Application for Variation of an Environmental Permit

C2. Application No. of the Current Environmental Permit : FEP-212/2022 (FEP-01/571/2019)

Proposed Golf Course Development at Tai Po Lot No. 246 Shuen Wan

Environmental Review Report for Application of Variation of Environmental Permit
(VEP)

Figure 4
圖四

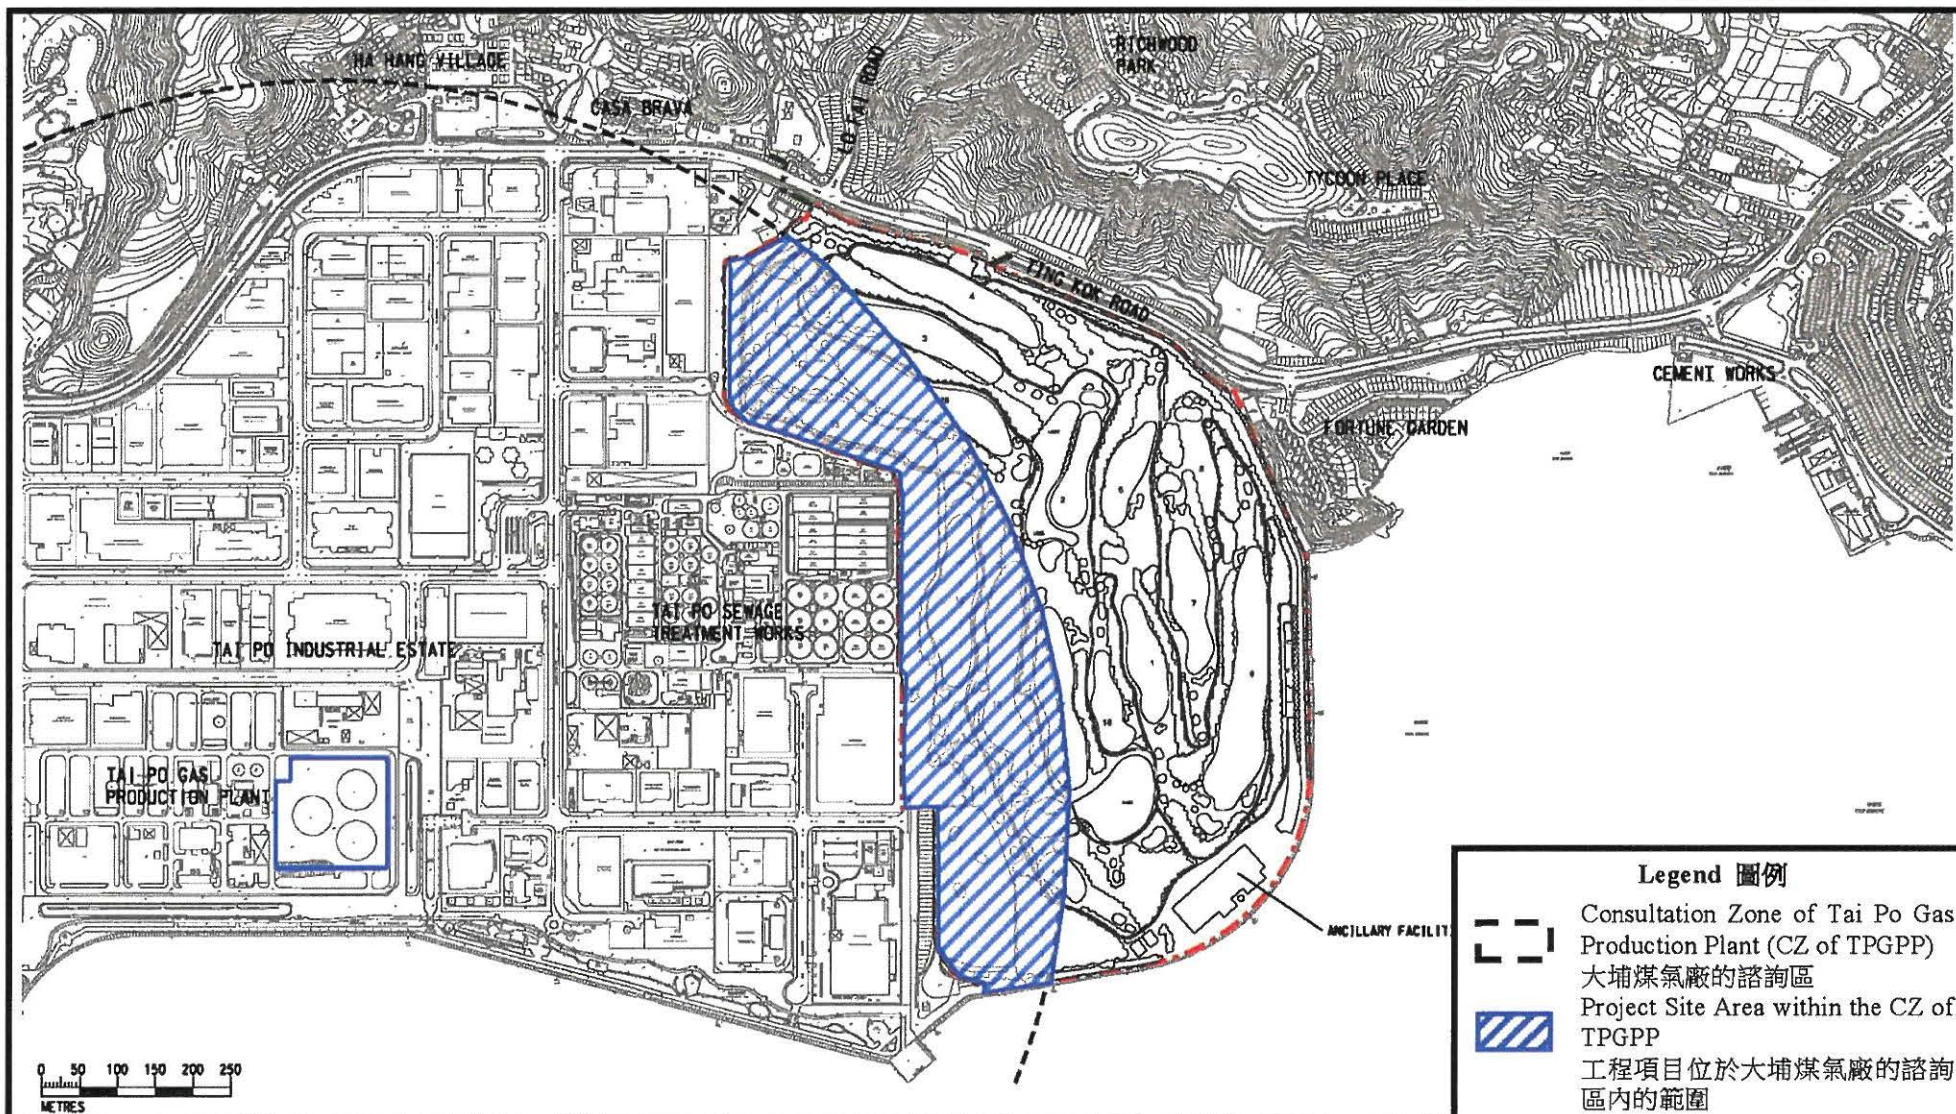
<p>Condition 2.48</p> <p>No permanent working or residential population shall be allowed within the Project Site area that falls within the consultation zone of Tai Po Gas Production Plant as shown in Figure 4 of this Permit during operation phase of the Project.</p>	<p>Proposed to be deleted.</p>	<p>The variation is proposed to meet the operation needs of the proposed golf course. Please refer to Section 4 of the ERR for Application of VEP.</p>

2.48 Figure 4	No permanent working or residential population shall be allowed within the Project Site area that falls within the consultation zone of Tai Po Gas Production Plant as shown in Figure 4 of this Permit during operation phase of the Project.	Clause 2.48 to be deleted.	Refer to Section 4 .
